## INSTRUCTIONS TO PERFORM RECALL CAMPAIGN 167

Certain Model Year Winnebago Certain 2021-2022 Inspire (Y34AE) Motorhomes.  
These motorhomes were manufactured from May 17, 2021, through November 23, 2021.

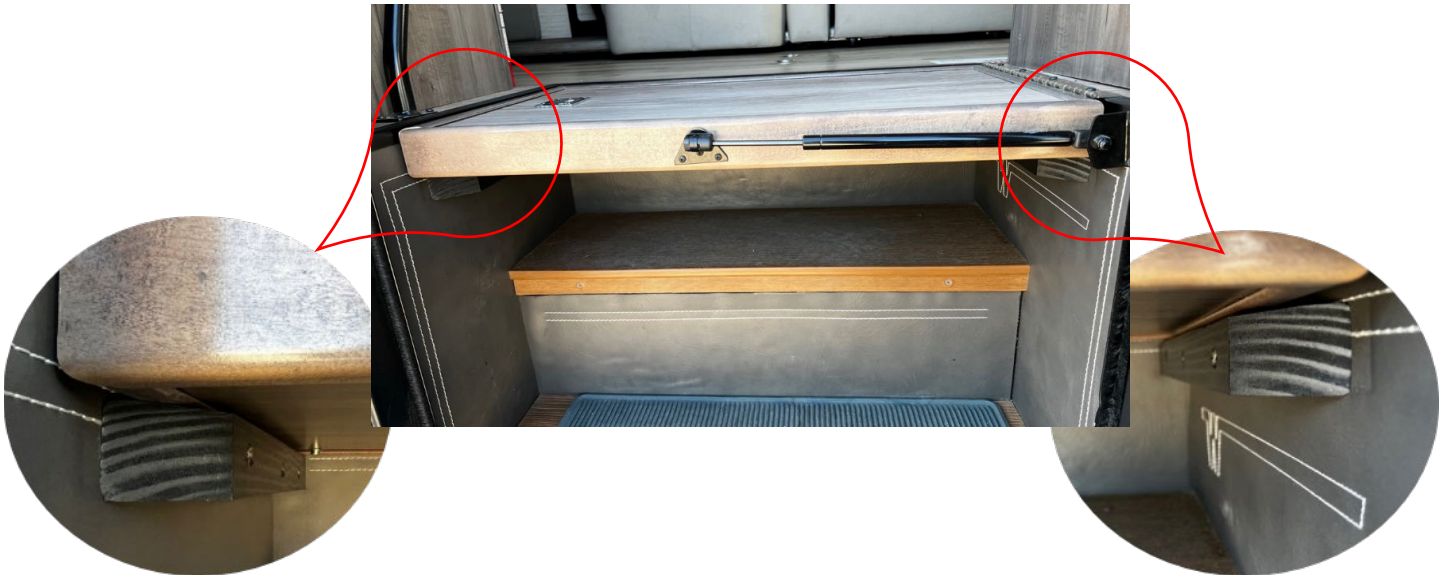
1. Remove screws that attach the two  $\frac{3}{4}$ " step supports. Discard screws and step support sticks

2. Using silicone fill the open screw holes left after removing the  $\frac{3}{4}$ " step support sticks.
3. Open recall kit RC7652-22-767 containing 2 - 1  $\frac{1}{2}$ " support sticks and the 6 fasteners.

4. Locate the 1 ½” support sticks from the kit, 2 ¼” from the top of the floor ( see photo below). Ensure the chamfer edge of stick points towards the door opening.

5. Use the fasteners provided in kit and screw it in place. Repeat procedure for the other side.
6. After installation ensure the step overlaps the support sticks (see photo below)
